**Report: Deficiency Report**  
**Function: Test, Adjust, & Balance**  
**Date: 02/18/2026**  
**Completed By: National TAB**

**PROJECT**  
**02-16-26 QT #1074 MONROE, NC**

QUIKTRIP  
4705 SOUTH 129TH EAST AVENUE  
TULSA, OK 74134

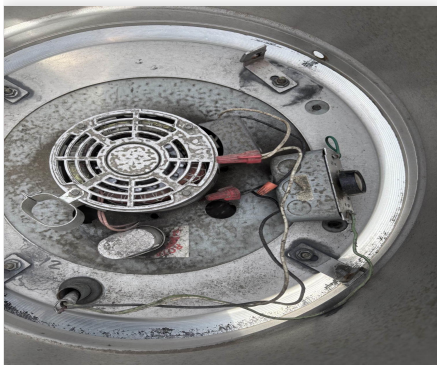
**Issue Name :** EF-2 speed controller doesn't work  
**Description :** The speed controller on EF-2 does not work. The combi oven grille is under design, and the men's restroom cannot spare enough air to bring it to design. The fan must be sped up.  
**Created By :** National TAB                      **Assigned To :** National TAB - Dan Hertenstein  
**Status :** Open  
**Priority :** High                                      **Asset Tag :** EF2  
**Originated Date :** 02/18/2026 - Christian Moller - National TAB

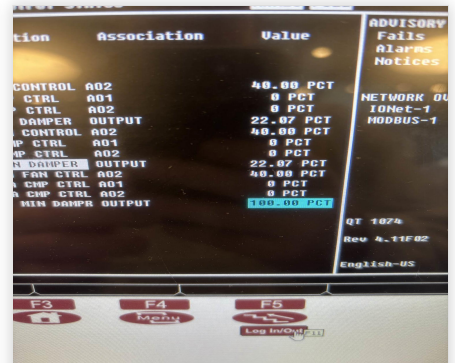
**Issue Name :** RTU 3 economizer not working  
**Description :** The economizer on RTU 3 does not respond to the Emerson board setpoints. For balancing purposes, the OA was set and left at the high speed position so is bringing in extra when the hood is off. Position was physically marked in the unit.  
**Created By :** National TAB      **Assigned To :** National TAB - Dan Hertenstein  
**Status :** Open  
**Priority :** Urgent      **Asset Tag :** RT-3  
**Originated Date :** 02/18/2026 - Christian Moller - National TAB
